Informal document **GRB-75-02-Rev.1-Add.1**  
75<sup>th</sup> GRBP, 8-11 February 2022,  
Agenda item 2,3, and 4(d)  
Companion document to GRBP-75-02-Rev.1

# **ISO 10844:2021 technical changes and benefits**

Figure 4 — Sieving curve area

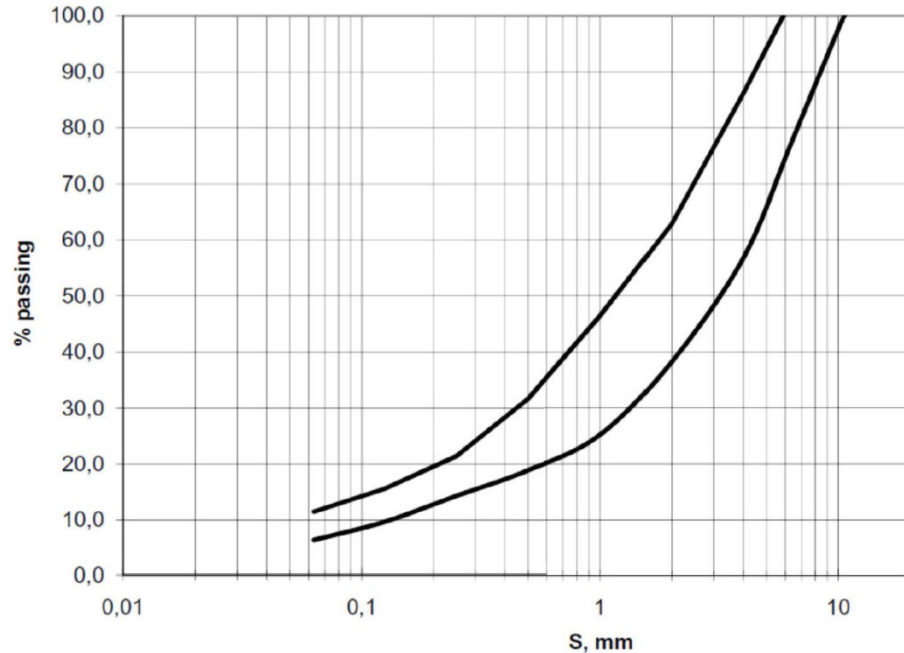
- Change: Graphs to table.
- Advantage: No curve interpretation results in **better accuracy**.
- **Benefit:** Reduced track-to-track variability caused by subjective interpretation of sieving curve figure.

Sieve size mm	Aggregate grading envelope requirement %
<b>Sieve category 1</b>	
14,0	100
13,2	100
12,5	100
11,2	100
<b>Sieve category 2</b>	
10,0	100
9,5	95 to 100
8,0	86 to 100
6,7	79 to 100
6,3	76 to 100

<b>Sieve category 5</b>	
0,63	20 to 37
0,60	20 to 36
0,50	18 to 32
0,425	17 to 30
0,315	15 to 25
0,30	15 to 25
0,25	14 to 22
<b>Sieve category 6</b>	
0,16	11 to 18
0,15	10 to 18
0,125	9 to 16
0,10	8 to 15
0,080	7 to 13
0,075	7 to 13
0,063	6 to 12
